# Technical Service BULLETIN

## FRONT AXLE HUB NUT REPLACEMENT

'92 - '98 Tercel, Paseo, Corolla, Celica, Camry  
'96 - '98 RAV4

DL001-98

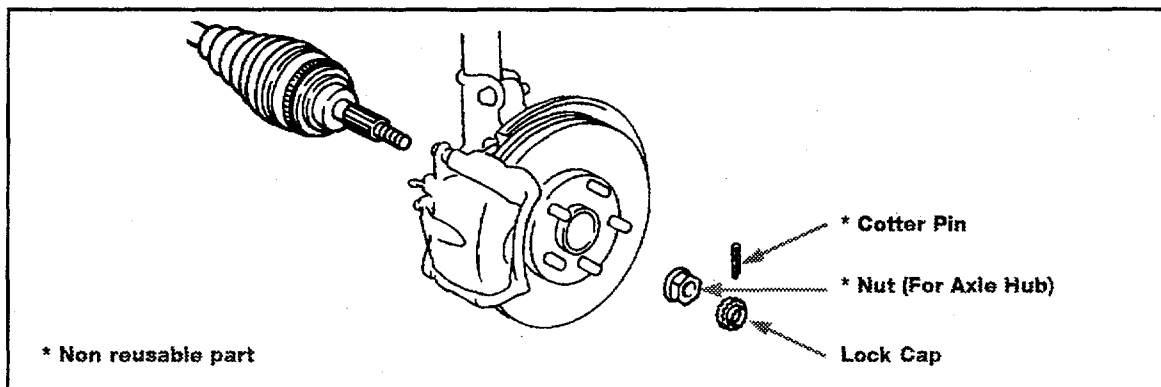
**Introduction** Due to a change of the friction control treatment on the nut thread, both types of Front Axle Hub Nuts (silver and black) for 1992 - 1998 Tercel, Paseo, Corolla, Celica, Camry and 1996 - 1998 RAV4s are **NOT reusable**.

When replacing the Front Axle Hub Nut the new part must be the same color as the old part. When replacing a Silver nut -- use a NEW Silver nut and when replacing a Black nut -- use a NEW Black nut.
